**Final  
After Action Report  
For  
North Lobe  
Dredging**

**New Bedford Harbor  
Superfund Site  
Operable Unit No. 1  
New Bedford, MA**

June 14, 2005  
2005-24-0028  
No Response Required

## North Lobe Dredging After Action Report Consolidated Response to Comments

## Appendix C.6

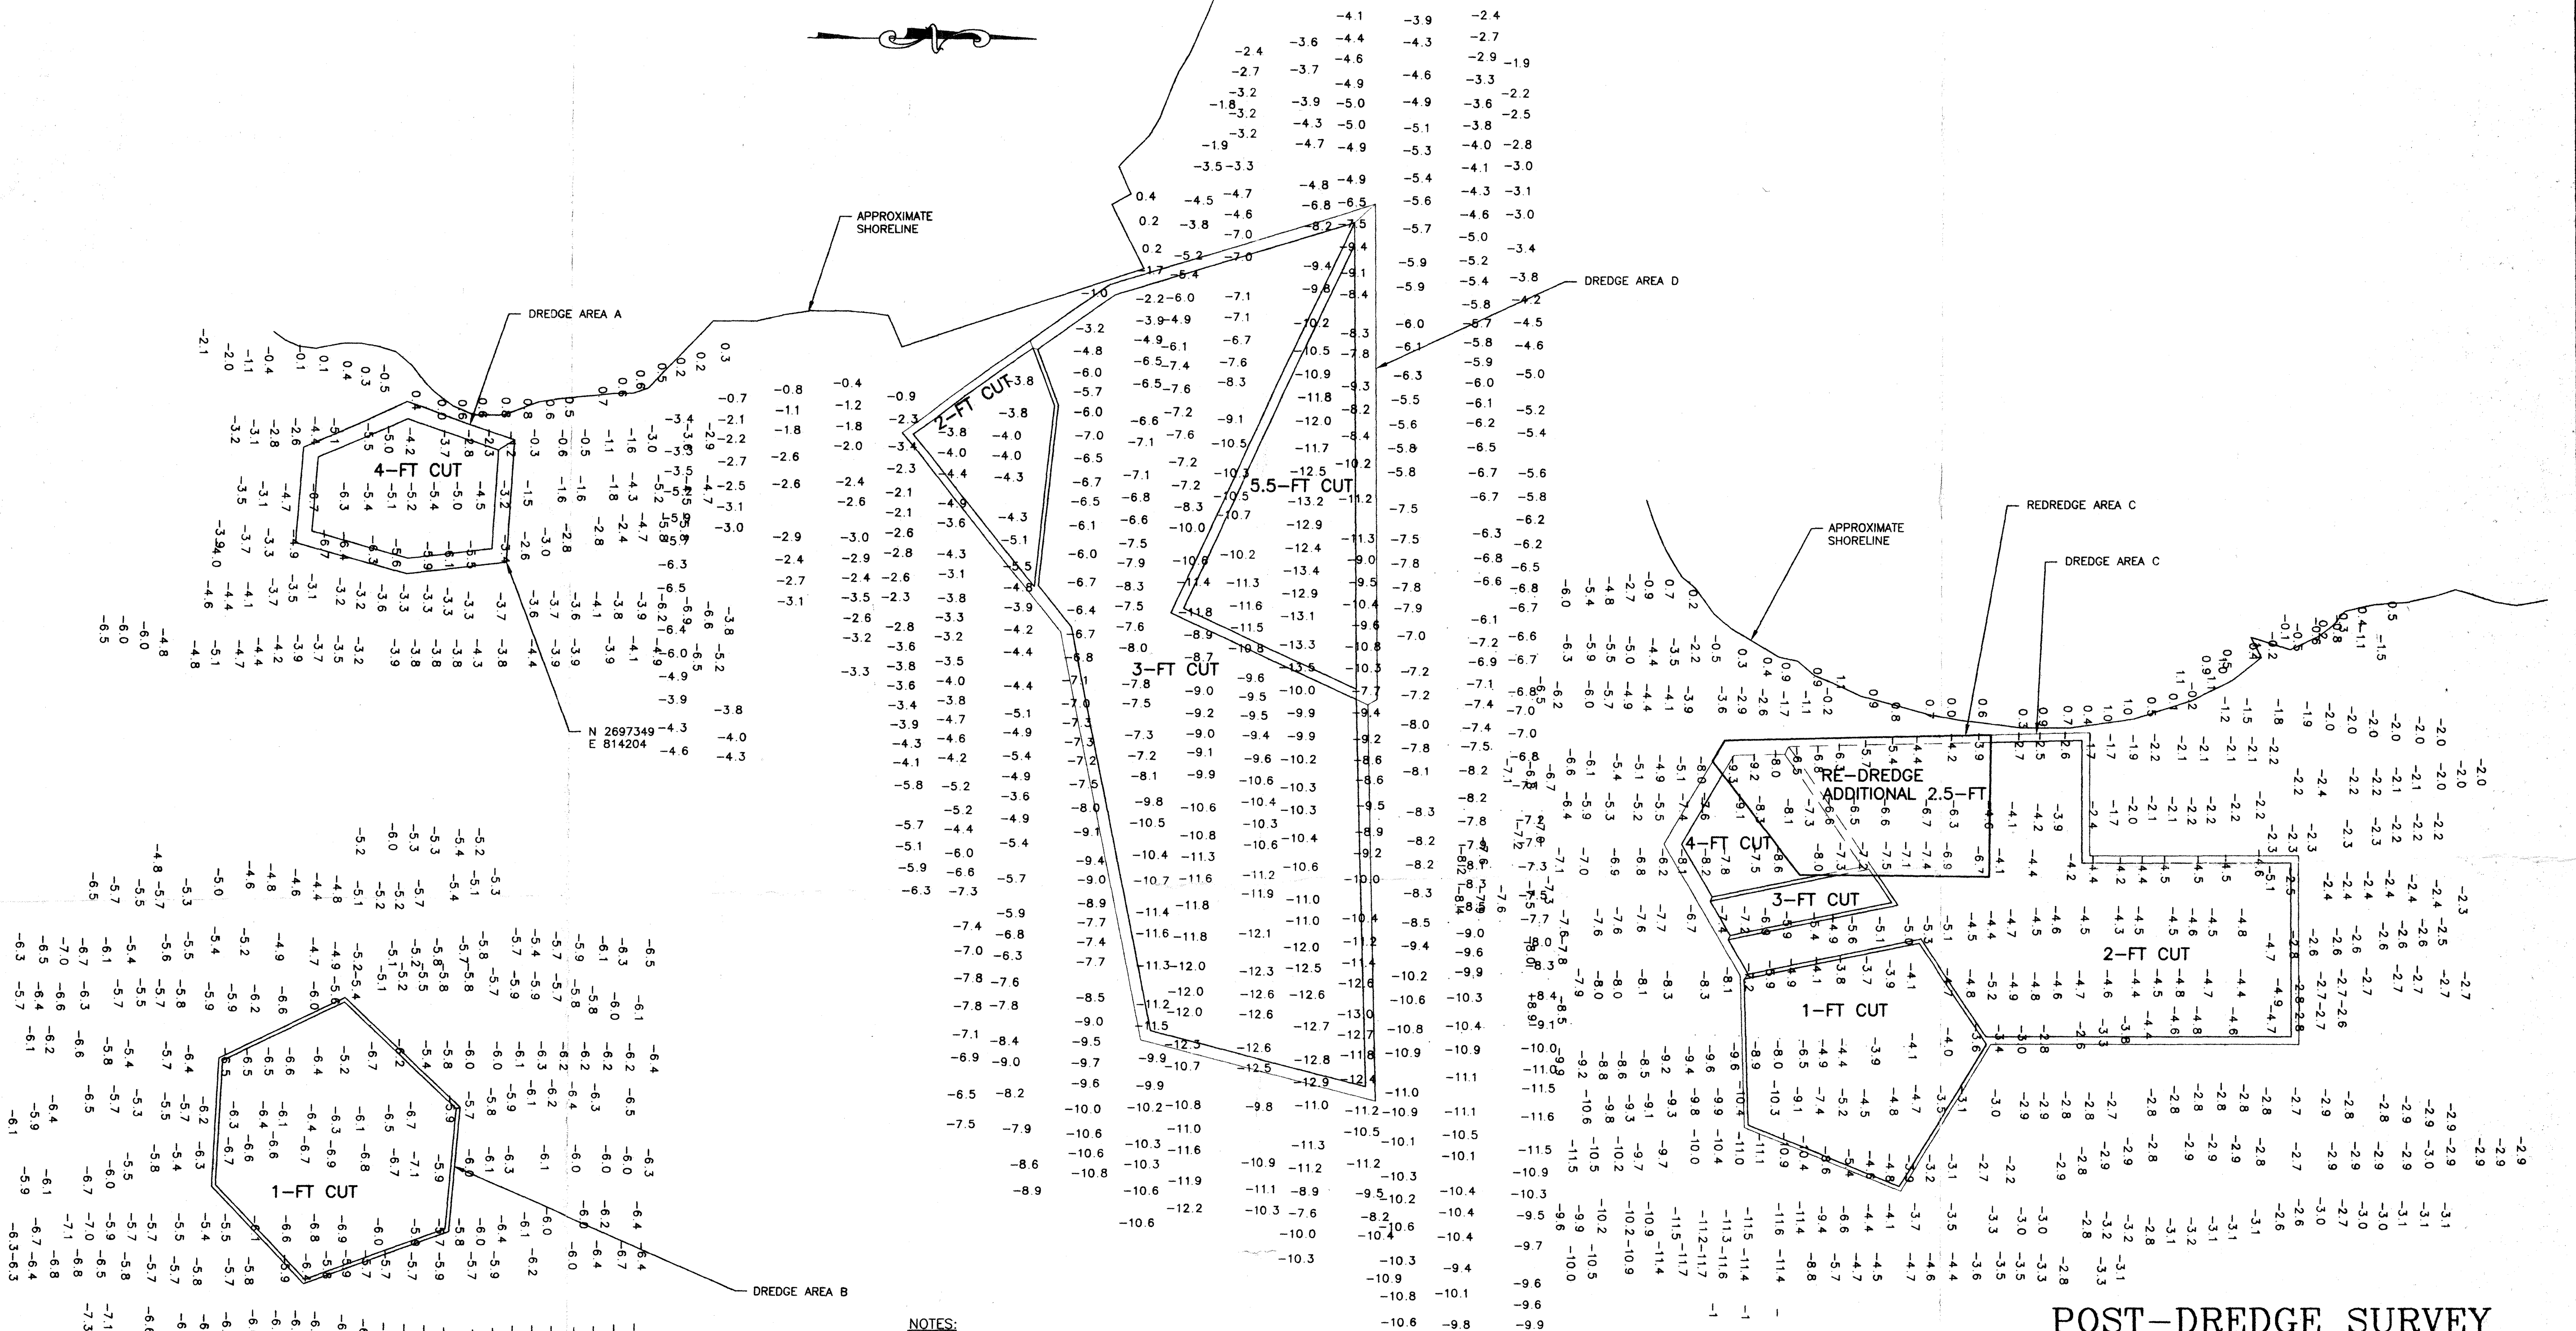
- \* Accepted
- Page iii, List of Appendices: After "Appendix C.5 Area D" insert "Appendix C.6 Plan View of All Areas" (as stamped & dated 1/03/04).
  - o Appendix C.6 was added as suggested. This is BCE Drawing 23468-02-01, dated 11/26/03. If USACE can supply a copy of the stamped and dated 1/03/04 drawing, then that version of the drawing will be included in the final report.

- A copy of the drawing provided by the USACE has been included in the report.
- Page iii, List of Appendices, Appendix C: Before "As-Built Surveys" add "BCE's".

**Appendix B**  
**Figure B-1 North Lobe Dredging Proposed Dredge Areas and**  
**Actual Confirmatory Sampling Locations**

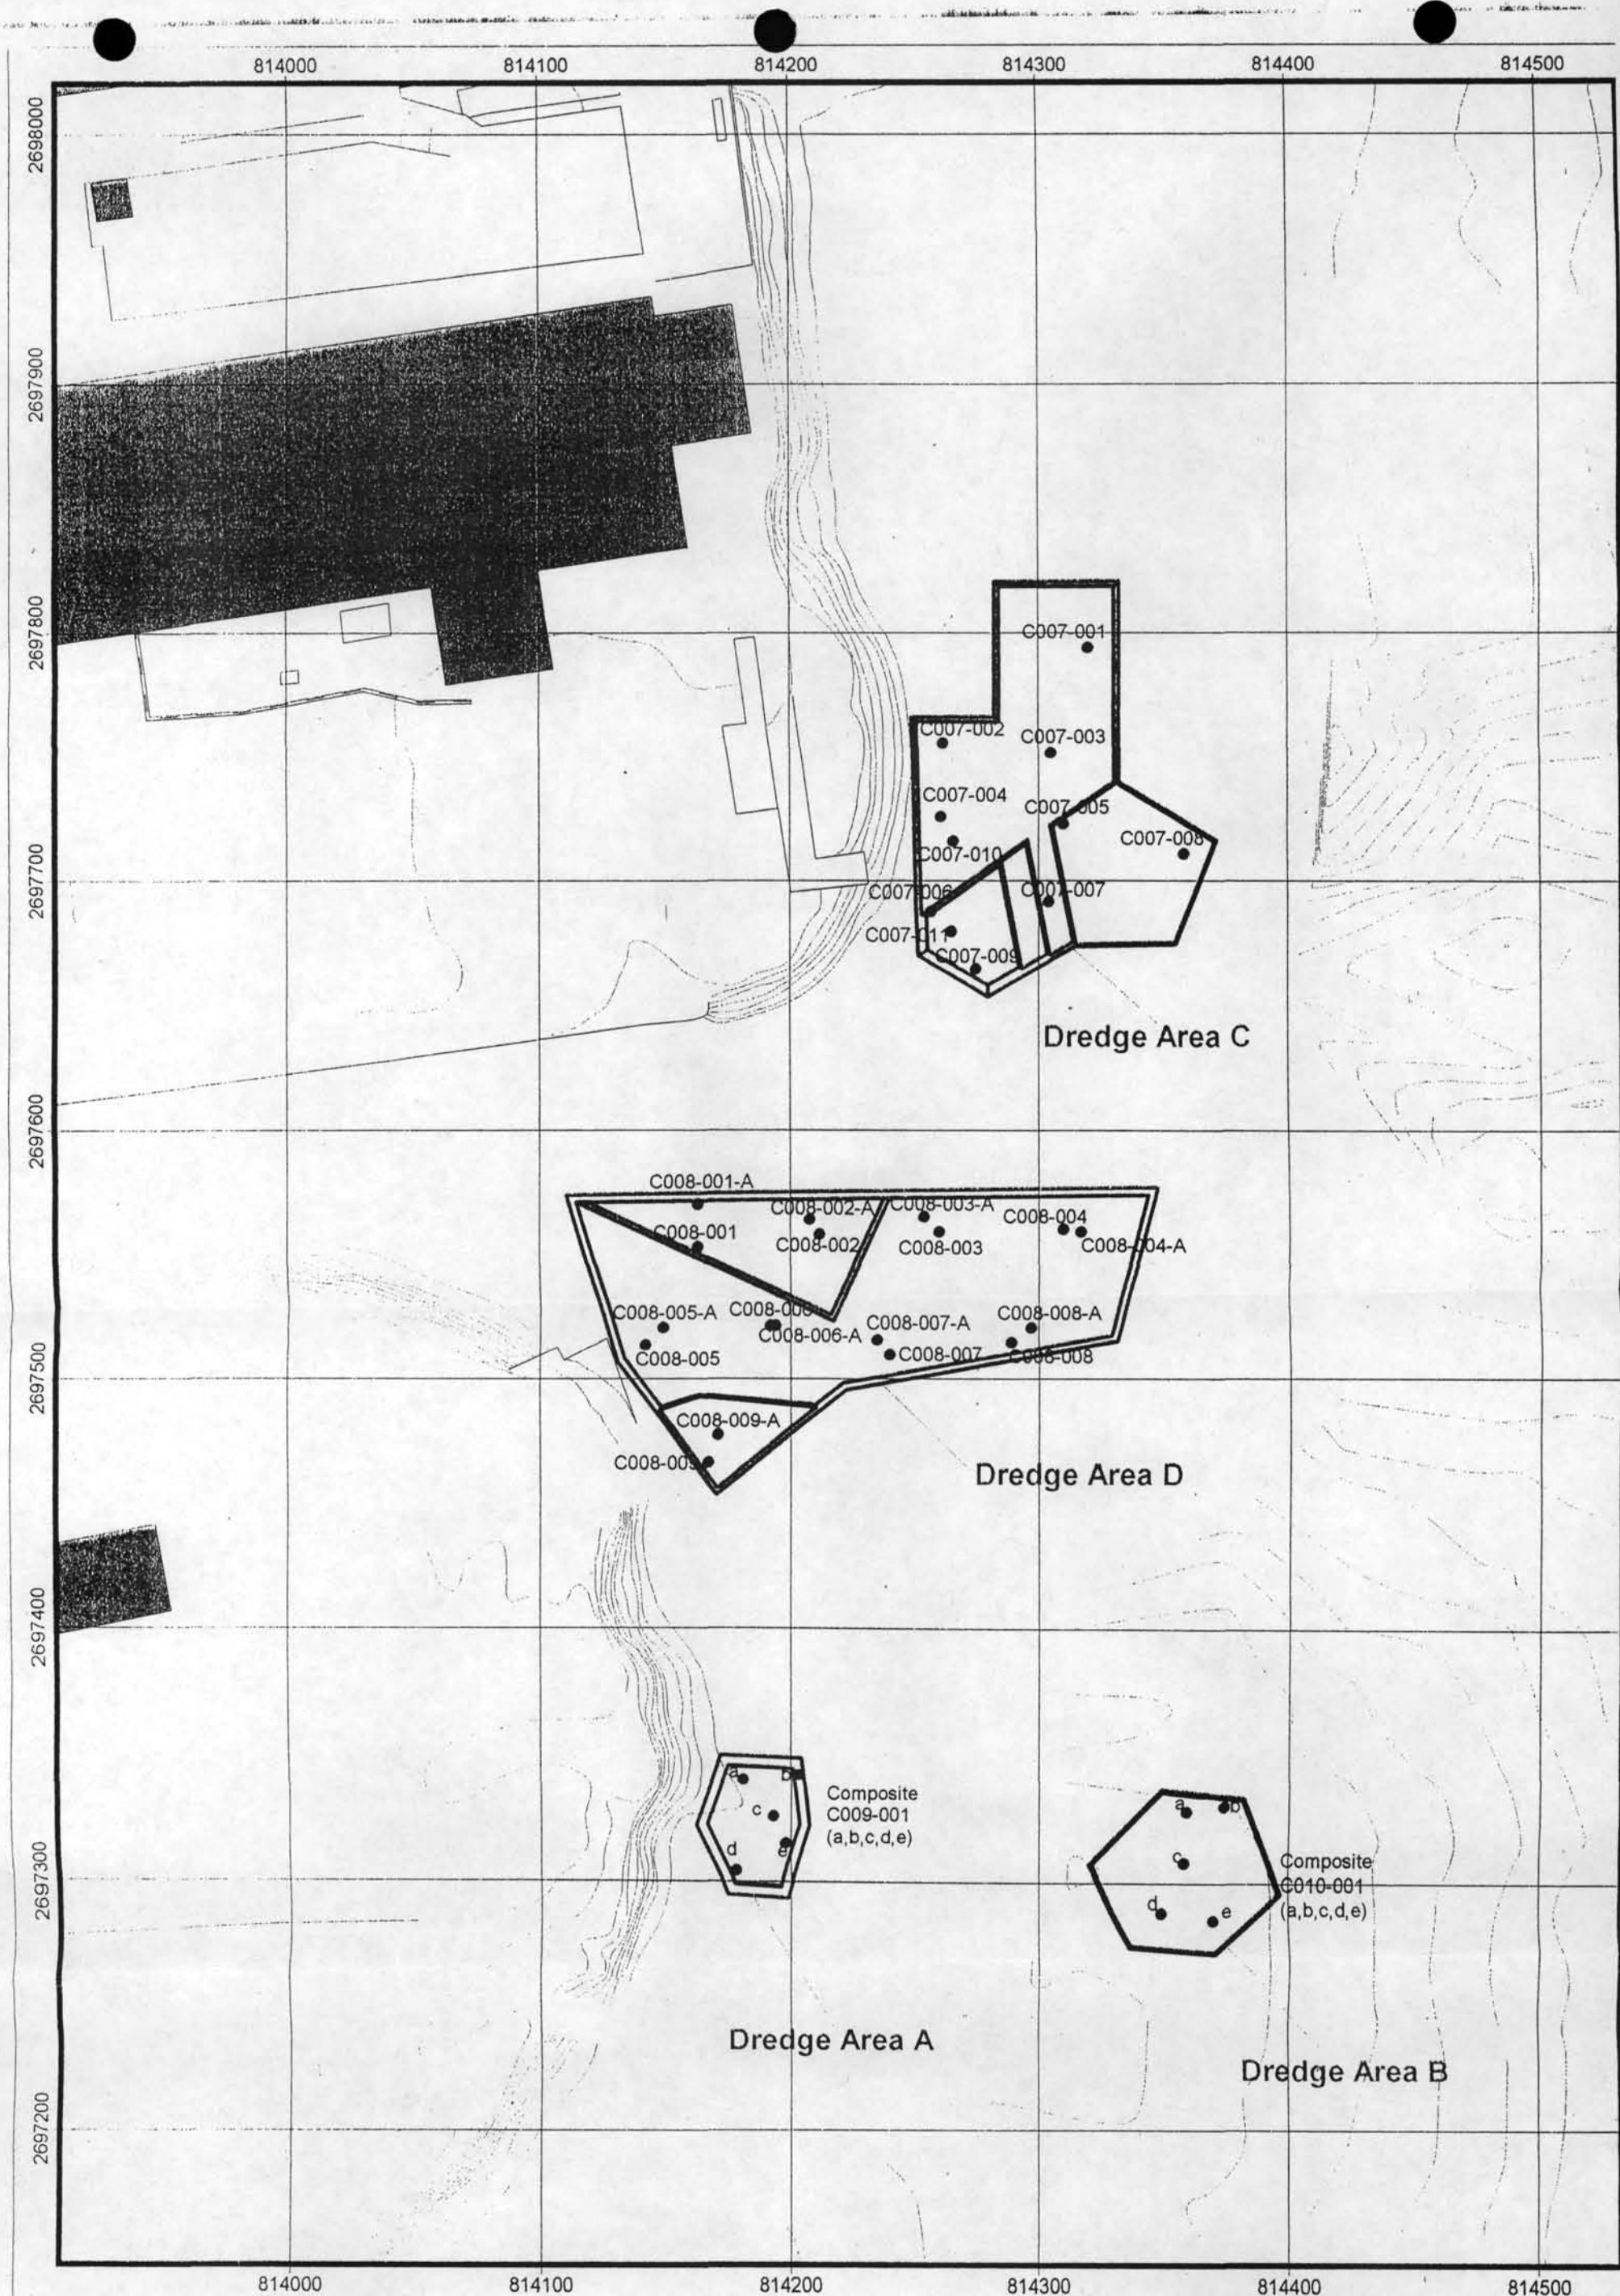
- \* Include a signed copy of the Eng. Form 4025 indicating that the Report has been approved. Figure B-1 of the Report is illegible and should be replaced.

- *The signed Eng. Form 4025 has been included as well as a legible copy of Figure B-1.*
